**Economic Commission for Europe****Inland Transport Committee****World Forum for Harmonization of Vehicle Regulations****165<sup>th</sup> session**

Item 4.6.4 of the provisional agenda

**1958 Agreement – Consideration of draft amendments  
to existing Regulations submitted by GRB****Proposal for Supplement 7 to the 02 series of amendments to  
Regulation No. 117 (Tyre rolling resistance, rolling noise and  
wet grip)****Submitted by the Working Parties on Noise and on Brakes and  
Running Gear\***

Figure 1

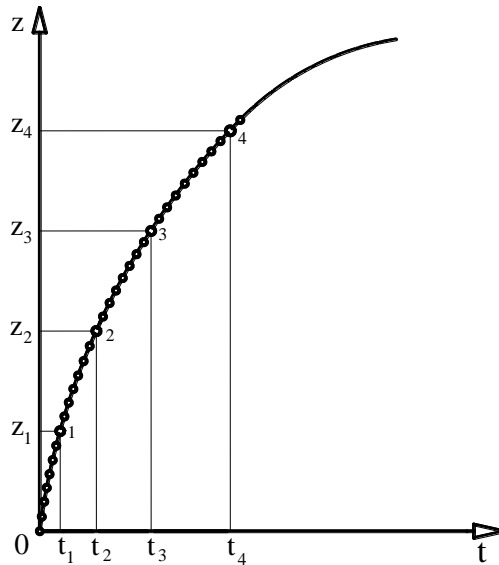
Insert a new Appendix 5, to read:

Deceleration method: Measurements and data processing for deceleration value obtaining in differential form  $d\omega/dt$ .

- Record dependency "distance-time" of rotating body decelerated from peripheral with a speed range such as 82 to 78 km/h or 62 to 58 km/h dependent on tyre class (Annex 6, paragraph 3.2., table 1) in a discrete form (figure 1) for a rotating body:

$$z=f(t_z)$$

$z$  is a number of body revolutions during deceleration;

$t_z$  is end time of revolution number  $z$  in seconds recorded with 6 digits after zero.

Note 1: The lower speed of the recording range may be reduced down to 60 km/h when test speed is 80 km/h and 40 km/h when the test speed is 60 km/h.
